BEFORE THE PUBLIC SERVICE COMMISSION  
OF THE STATE OF MISSOURI

In the Matter of the Resource Plan of                    )  
KCP&L Greater Missouri Operations                    )  
Company    )                    File No. EO-2013-0538

**COMMENTS OF SIERRA CLUB**

Figure 5: Annual DSM energy for RAP and MEEIA-RAP alternatives

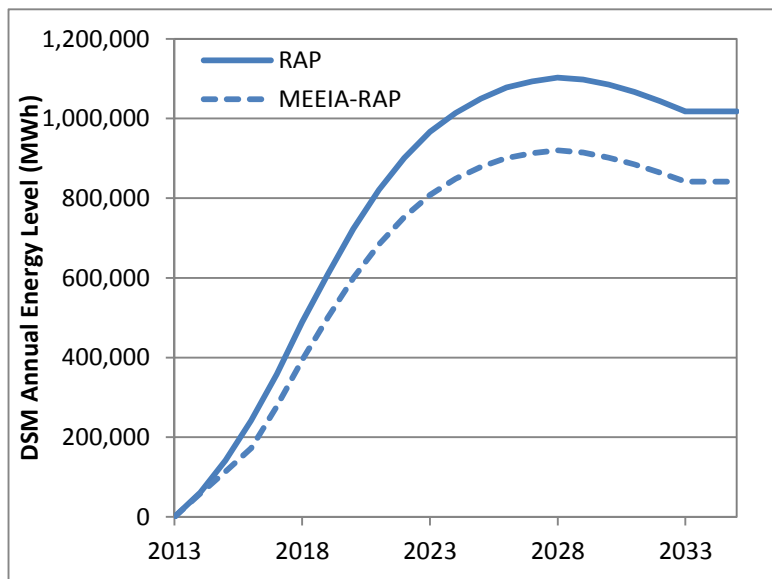
KCP&L’s adjusted MEEIA-RAP forecast is compared to RAP in Figure 5. The reduced spending over a few early years cascades forward, resulting in substantially less cumulative DSM energy savings over the study period. This difference results in the substantial difference in costs and rates of the two plans discussed above.

**Figure 6: DSM capacity from Navigant Report and KCP&L’s plans**

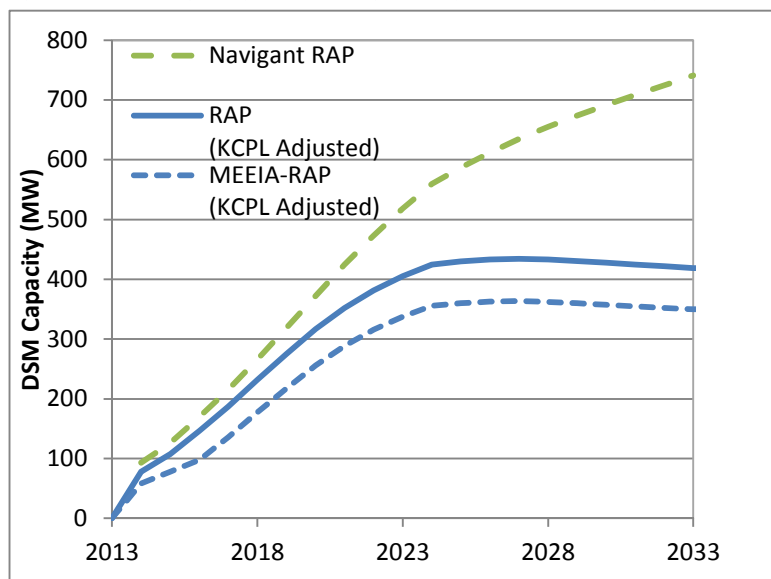
In addition to being an essential low-cost energy resource, DSM also provides demand savings in the form of peak reductions. The cumulative demand savings potential from the Navigant study (Appendix L) grows every year, as shown in Figure 6, eventually rising to a total of 741 MW for KCP&L in the RAP scenario, including energy efficiency (EE), demand response (DR), and combined heat and power (CHP). KCP&L’s Stakeholder Report (Appendix B) shows a peak DSM capacity of only 432 MW for the RAP scenario, and 363 MW for the MEEIA-RAP scenario. After the peak year in 2026, the capacity savings associated with DSM flattens and subsequently declines. It is unclear why this decline exists, given the Navigant study’s finding of a steadily increasing potential out to 2033. While Navigant shows annual savings may decline as the market becomes more saturated (as indicated for energy in Figure 5), cumulative capacity should continue to increase.
